Valentin Residence

ADDRESS ESA
RECOMMENDATIONS
TO CRITICAL AREAS
REPORT
June 8th, 2018

File No. CAO17-003 – Valentin Critical Areas
Determination

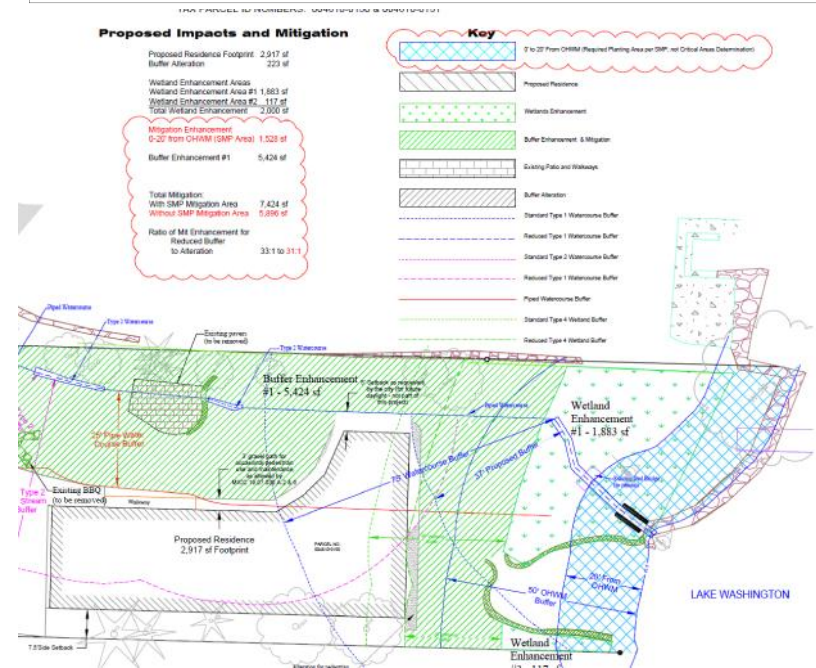
ESA Recommendation #1: The shoreline management requirements are separate from the wetland and stream buffer reduction requirements so the area within 20 feet of the Ordinary High Water Mark should not be included in the wetland and stream buffer calculations consistent with MICC 19.07.110(9)(d)(i). These areas shall be removed from the mitigation ratio calculations for buffer reduction.

The 20' SMP area now has a unique key to distinguish from the buffer enhancement. The calculations list SMP area separate from buffer enhancement.

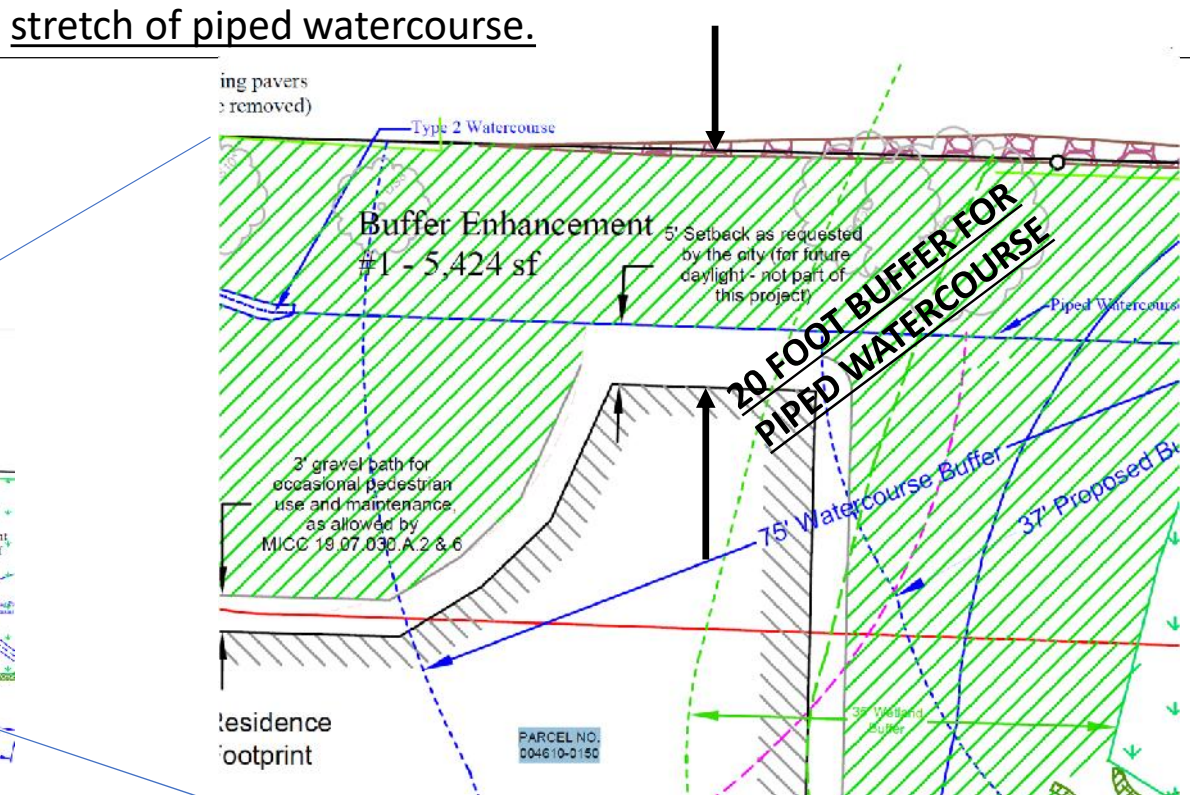
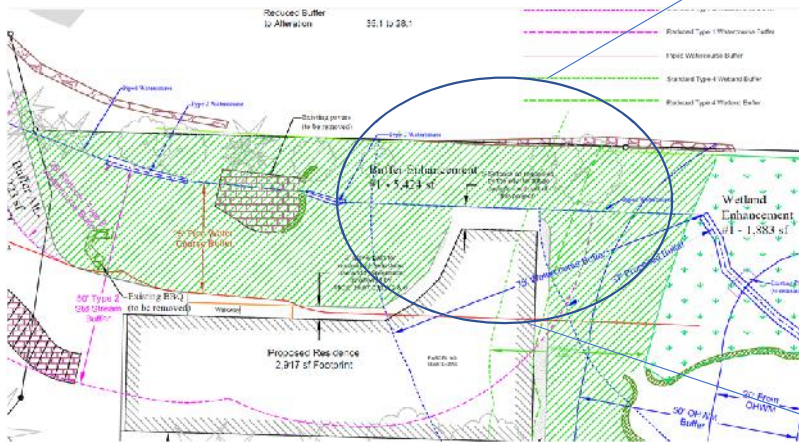
ESA Recommendation #3: The 5-foot buffer proposed for the piped portion of the stream adjacent to the eastern side of the residence could inhibit *future daylighting* of the stream due to its narrowness. A minimum 10-foot buffer shall be provided.

Response: The applicants Biologist has analyzed the terrain and positively concluded that the 20 foot buffer and five foot setback provided will not inhibit future daylighting. The Biologist has analyzed the grade, depth and overall size of the area in question. Please see details below and in the revised report.

Future daylighting, although encouraged, is not a code requirement or criterion for approval for an 18 foot stretch of piped watercourse.

Grade: 1" per foot

Depth: <3"

- The piped watercourse will be in a 20 foot wide area between the building envelope and the northern property line (The City's planning director had originally proposed placing the stream in a 10 foot area which would have allowed for only a maximum of five feet on each side).
- The five foot setback/distance from the piped watercourse to the building envelope is limited to 18 feet (see picture on previous slide).
- The slope is 1" per foot, and so the area in question is relatively flat (see picture on previous slide).
- The depth of the pipe is less than three inches (see picture on previous slide).
- Future daylighting, although encouraged, is not a code requirement or criterion for approval for an 18 foot stretch of piped watercourse

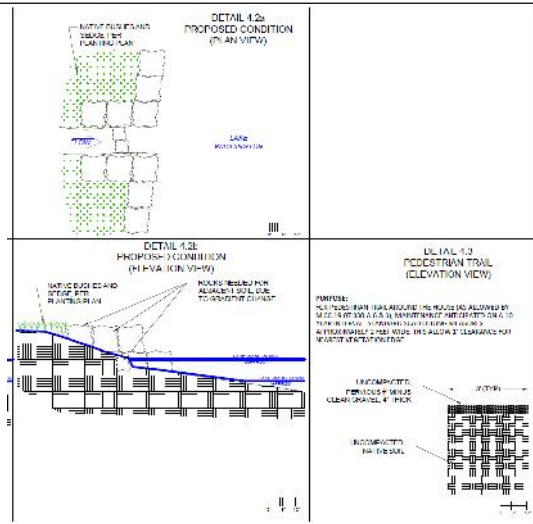
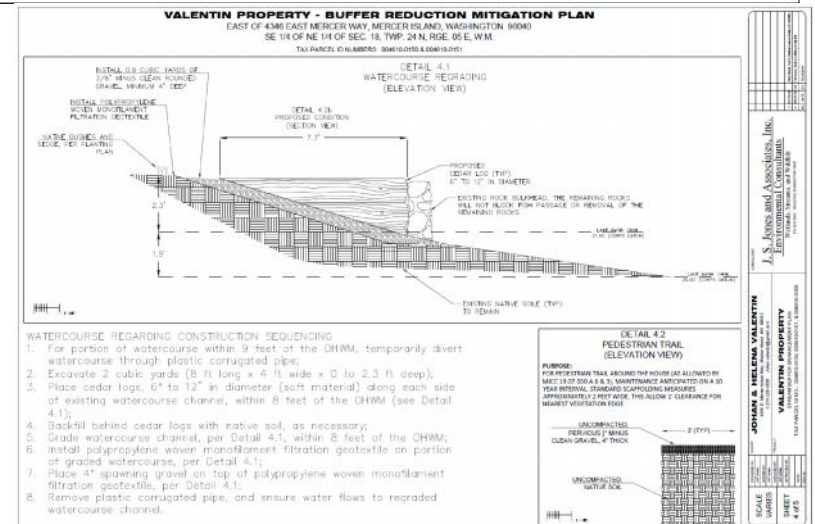
Please provide additional detailed information for the proposed fish blockage removal. Provide the total area of excavation and grading within the stream, the proposed construction sequencing, the engineering design versus conceptual plan, and a statement that the remaining rocks in the stream channel will not block fish passage or removal of the remaining rocks.

- a. The total area of excavation and grading of the watercourse has been added to Sheet 4 of 5.
- b. The details of construction sequencing has been added to Sheet 4 of 5.
- c. More detailed design has been added to sheet 4 of 5.
- d. The following statement has been added to Sheet 4 of 5:

The remaining rocks in the stream channel will not block fish passage, nor will removal of the remaining rocks.

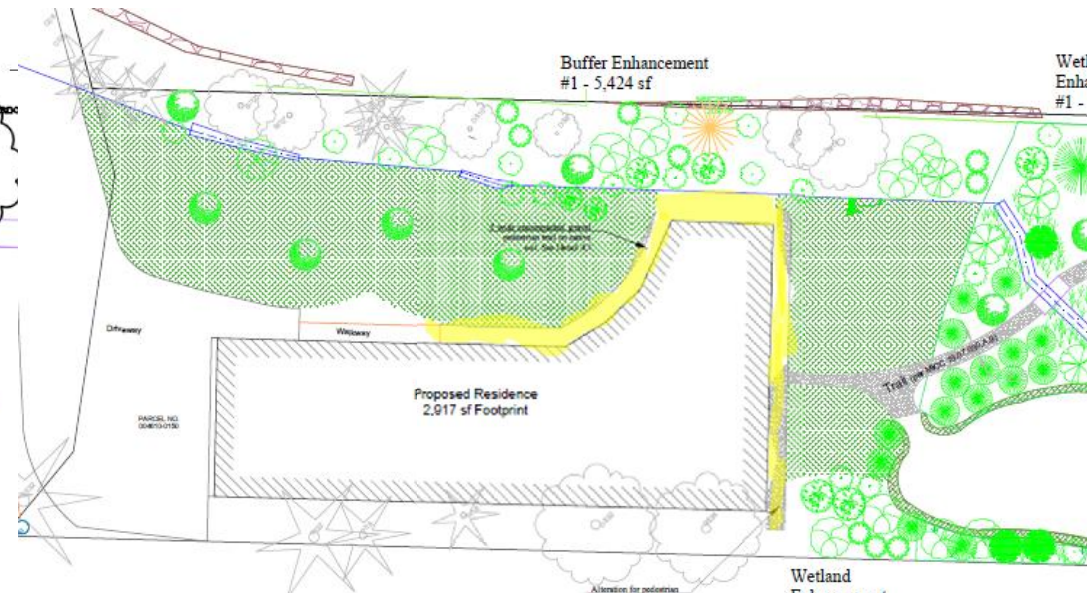
ESA Recommendation #1: The footprint of the proposed house extends to the edge of the reduced buffer. This does not allow adequate room for construction and maintenance of the proposed house without disturbing the buffer. Please add an adequate setback (not less than 5 feet in width) from the buffer for construction, and ongoing access and maintenance.

Although not required by code we have created a 3-5 ft path around the entire residence by revising and reducing the footprint. In most areas the path is outside the buffer. In limited areas the path is inside the buffer as an allowed alteration per MICC 19.07.030.A.6.

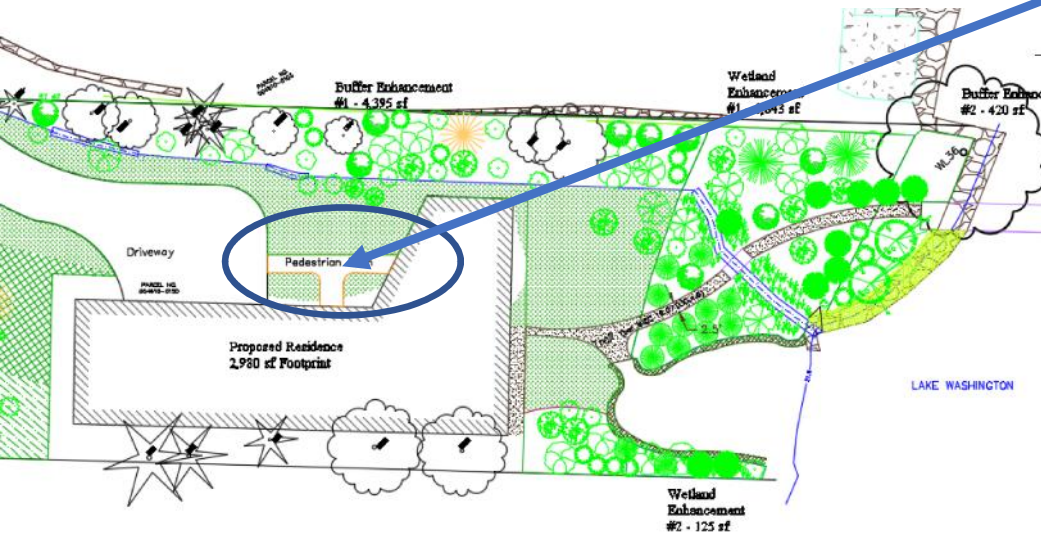
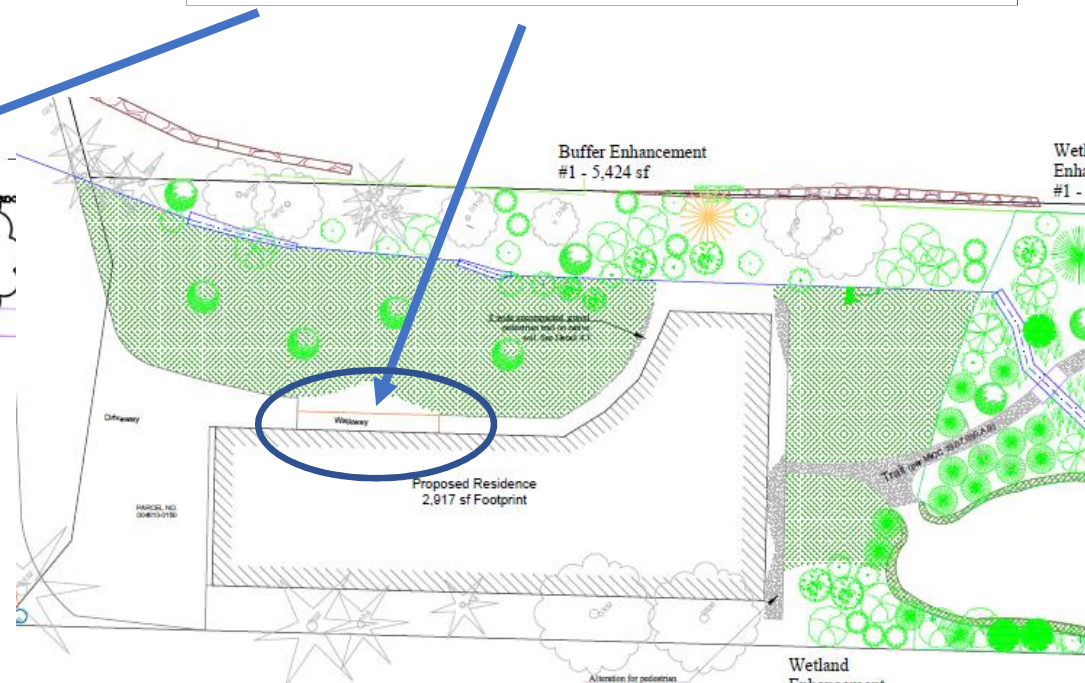
ESA Recommendation #2: On the plans, the walkway from the elongated parking area leading to the proposed house is labeled as a trail. This area is a walkway, not a trail. Please relabel as walkway. Walkways are not allowed in buffers, so the walkway must be removed from the reduced buffer area.

Walkway completely removed from within the reduced buffer.

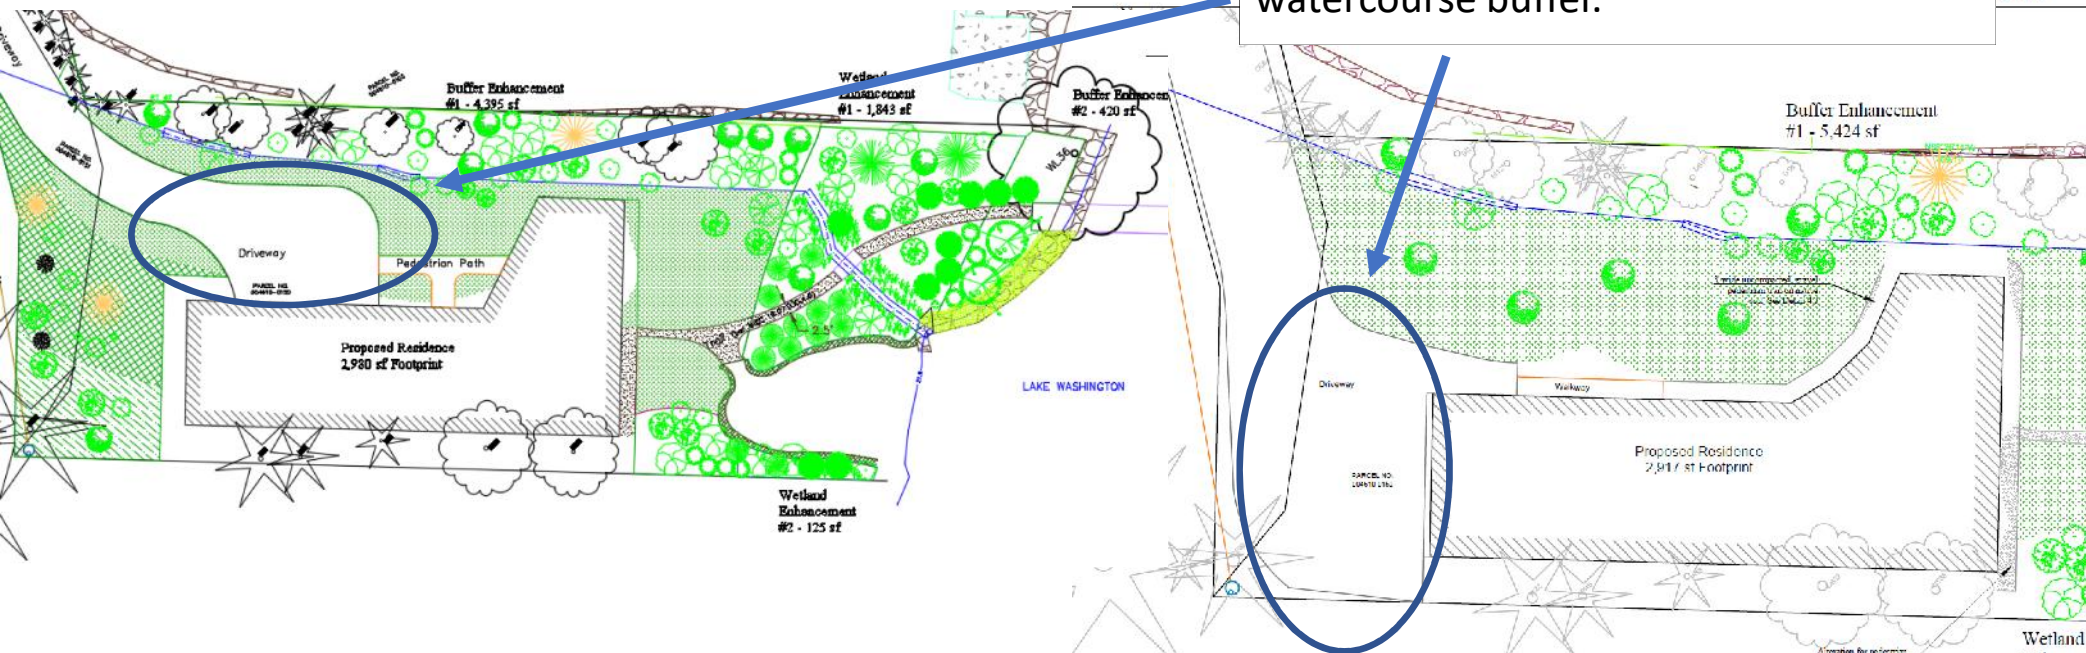
ESA Recommendation #3: To mitigate for reduced watercourse buffer widths, the project proposes to employ option (iii) under MICC 19.07.070(B)(2): removal of invasive species and ornamentals, replanting with native trees, shrubs, and herbaceous plants, and five-year monitoring. In addition, this mitigation type is proposed throughout Wetland A and most of the buffer areas. The enhancement activities are generally appropriate mitigation for the proposed reduced buffers. However, much of the Type 2 watercourse buffer is comprised of driveway pavement and parking area; a driveway crossing is allowable per MICC 19.07.030(A)(6); however, additional mitigation must be provided to offset the new intrusion of driveway in the buffer.

Driveway and parking area completely removed from the reduced Type 2 watercourse buffer.

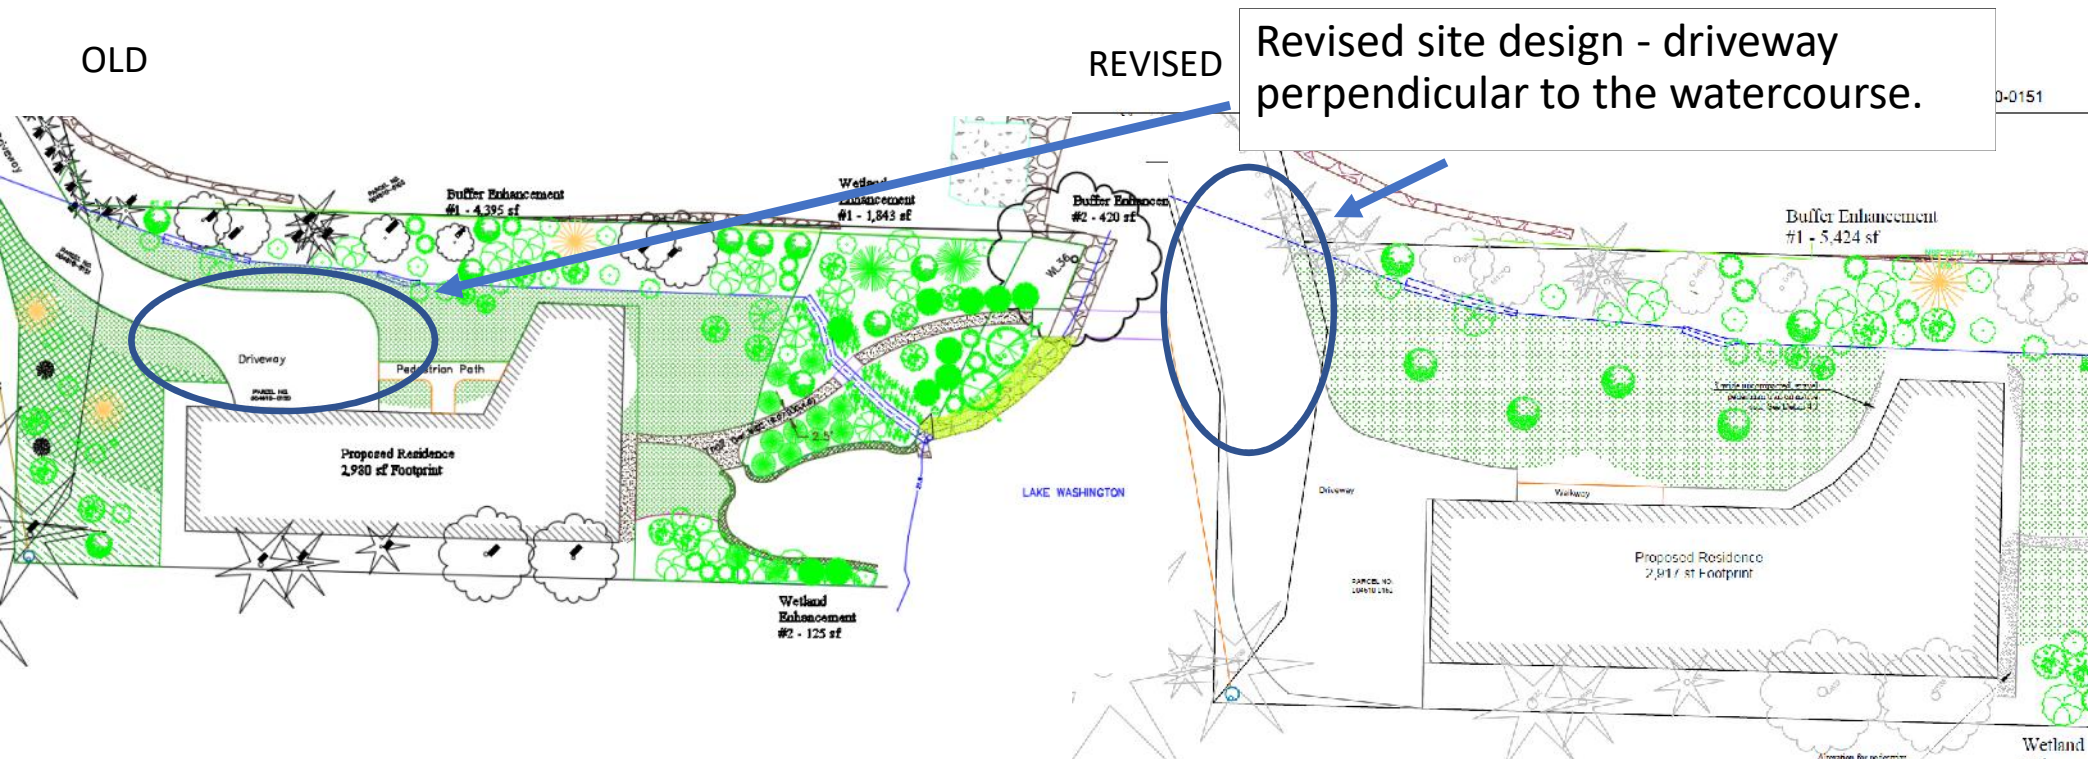
ESA Recommendation #4: A portion of the proposed driveway including the parking area at the terminus of the driveway is parallel with the water course within the buffer and is located within the reduced watercourse buffer. While driveways are allowed in buffers pursuant to MICC 19.07.030(A)(9), the layout is not consistent with best available science and does not avoid impacts to the reduced watercourse buffer. Best available science allows driveways to be placed in buffers perpendicular to critical areas to pass through or cross over the critical area. Please realign the driveway to be perpendicular to the watercourse to ensure no net loss of watercourse and buffer functions; a revised site design is appropriate.

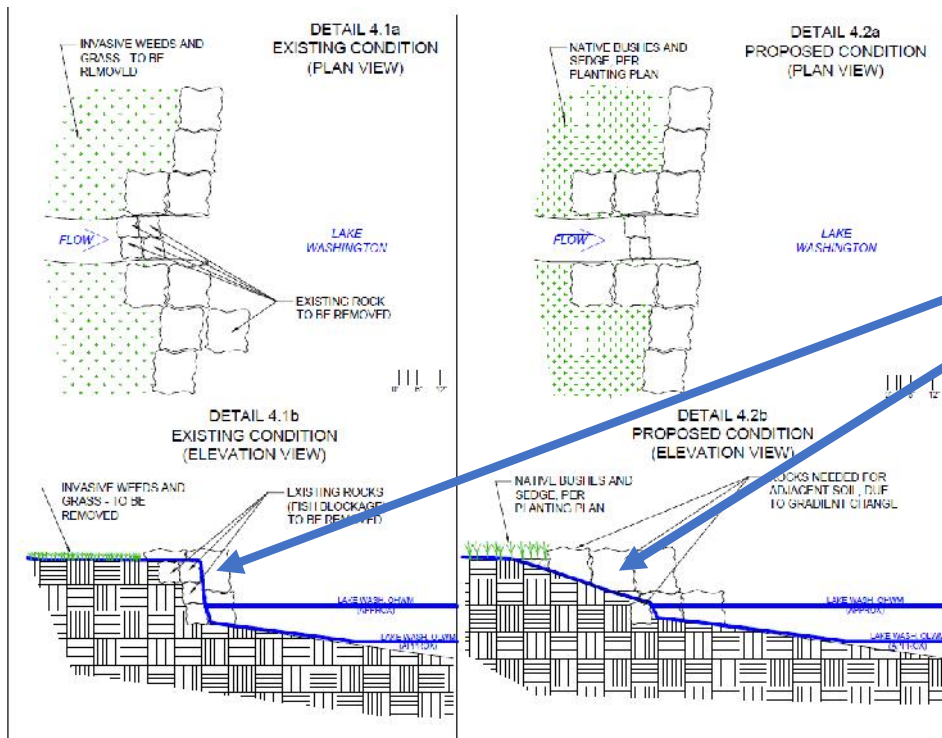
ESA Recommendation #5: The Critical Areas Study proposes mitigation via habitat enhancement within the watercourse with log placement. The stream is too narrow to benefit from log placement. Rather than log placement, please remove or soften the existing rock bulkhead adjacent to the watercourse outlet to the lake. As part of this work, remove all blockages between the lake and the outlet.

Soften existing rock outlet and remove blockage, see proposed design detail to the left.

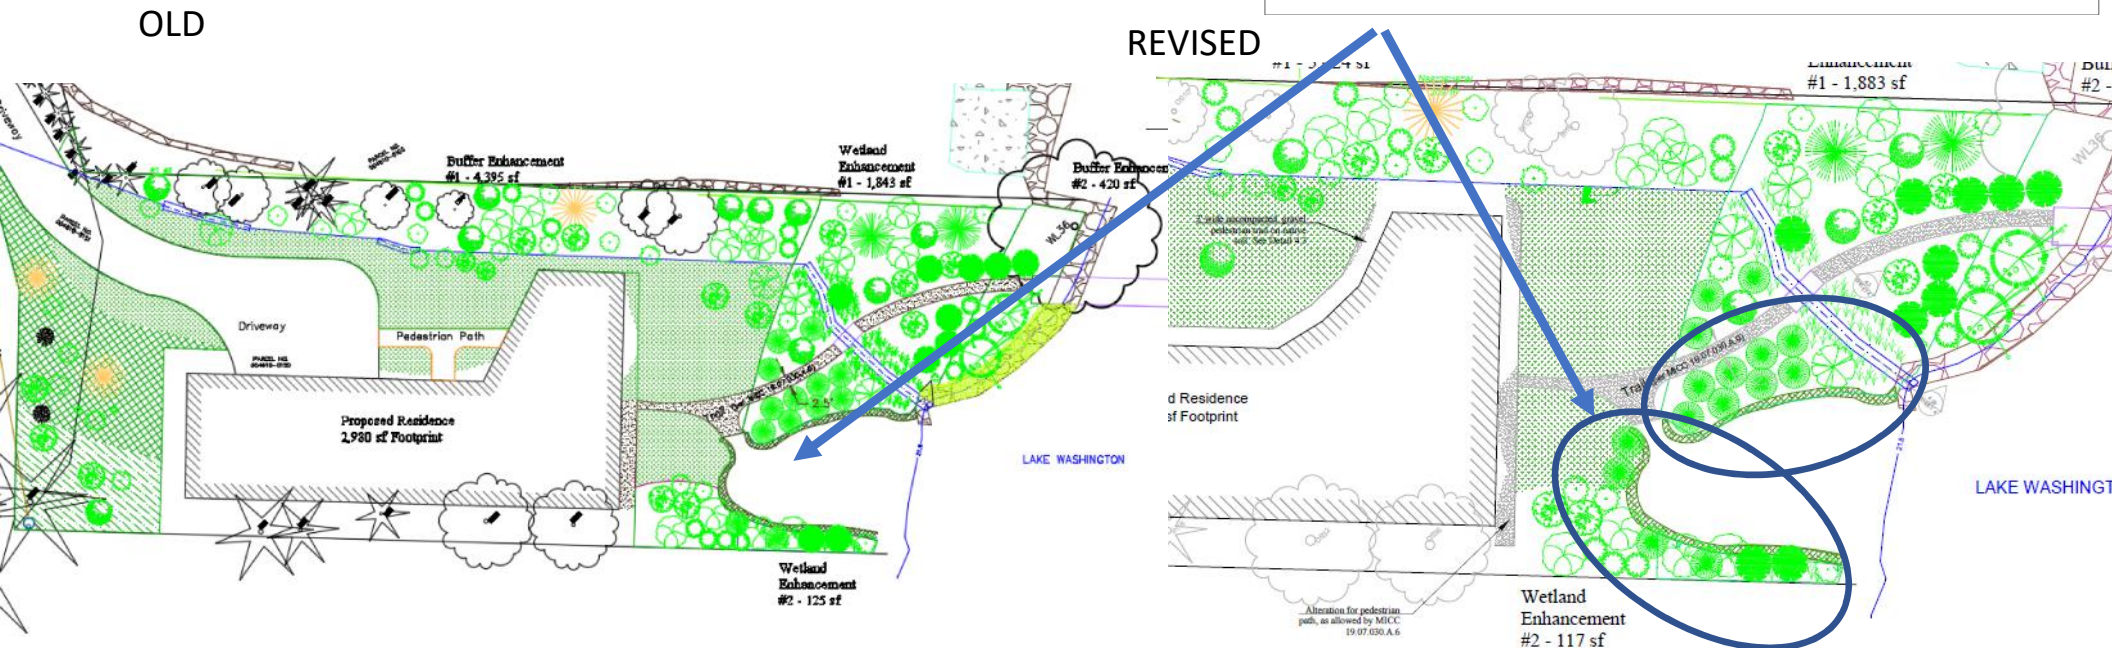
ESA Recommendation #6: Pursuant to MICC 19.07.110(E)(9)(d)(i), native vegetation should be planted to meet or exceed 75 percent cover in the area within 20 feet of the Lake Washington OHWM. However, a sandy cove exists within this 20-foot area. To meet the intent of the code, please enhance the proposed plantings adjacent to the cove by adding native shrubs that will provide habitat value not provided by the proposed groundcover plantings in this area.

Added plantings adjacent to cove which are all native shrubs. In addition, the cove itself provides enhanced habitat.
